MILLER FAMILY DIVISION SUBDIVISION

APPLICATION NUMBER 1 DATE July 24, 2008
APPLICANT Miller Family Division Subdivision
REQUEST Subdivision

DETAIL SITE PLAN

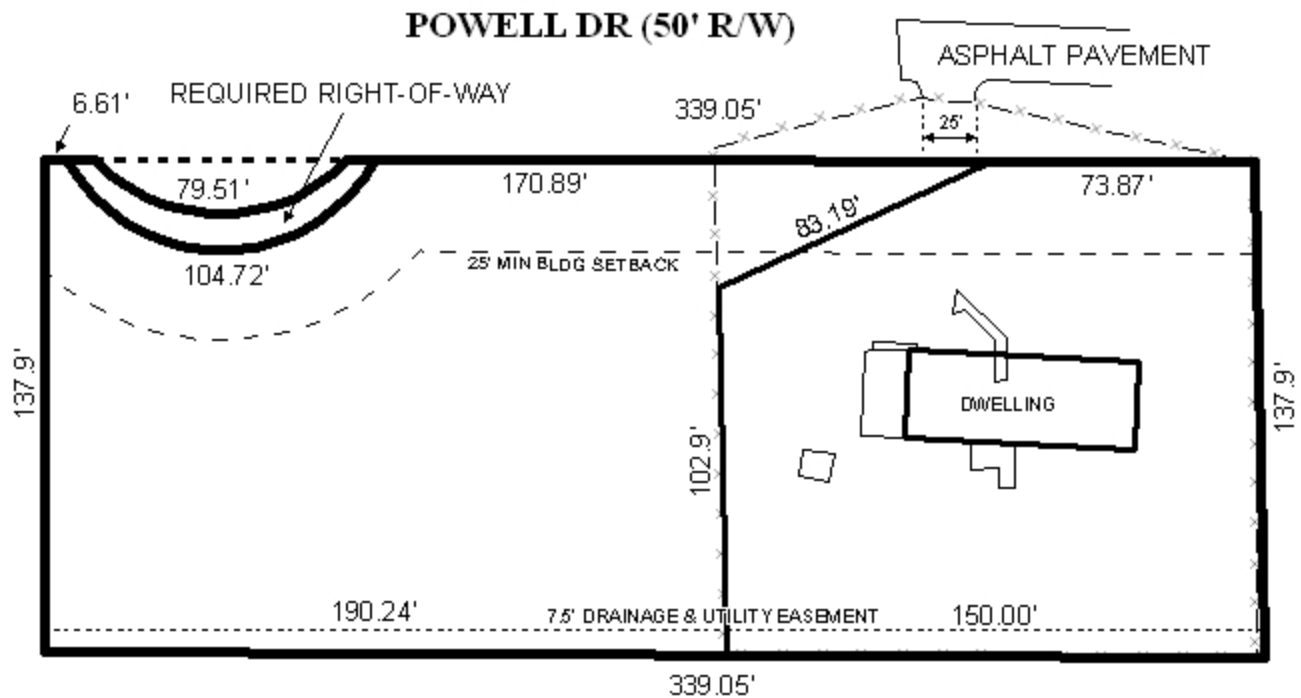
Powell Drive also is a dead-end lacking a built cul-de-sac. The plat depicts the existing right-of-way portion of an un-built cul-de-sac (as shown on the 1964 plat), however, the size is only a 50-foot radius that does not appear to be centered on the right-of-way. The plat should be revised to ensure that the cul-de-sac radius is centered on the right-of-way, and the 25-foot minimum building setback line, depicted on the plat, should be revised to accommodate the dedication that may be required by the proper location of the cul-de-sac radius.

Since each lot will be served by public water and an individual septic system, the minimum required lot size is 15,000 square feet. It appears that each lot will meet the minimum size requirements, however, the plat should be revised to label each lot with its size in square feet.

- 1) Revision of the plat to reflect (and show dedication of) right-of-way necessary to center the 50-foot radius cul-de-sac in the existing right-of-way;
- 2) Revision of the plat to adjust the 25-foot minimum building setback line to reflect the cul-de-sac revision;
- 3) Revision of the plat to either modify the lot lines to show Lot 2 having 25-feet of frontage on the existing paved portion of Powell Drive, or the extension of the street to provide the frontage;

- 4) Revision of the plat to depict any existing structures that will remain, and their respective setbacks;
- 5) Placement of a note on the plat stating no future subdivision of either lot shall occur until additional frontage on a public street is provided (construction of remainder of Powell Drive to City standards, including the cul-de-sac);

- 10) The labeling of the lots with their size in square feet.

A revised site plan was submitted, reflecting all of the requested revisions and notations.
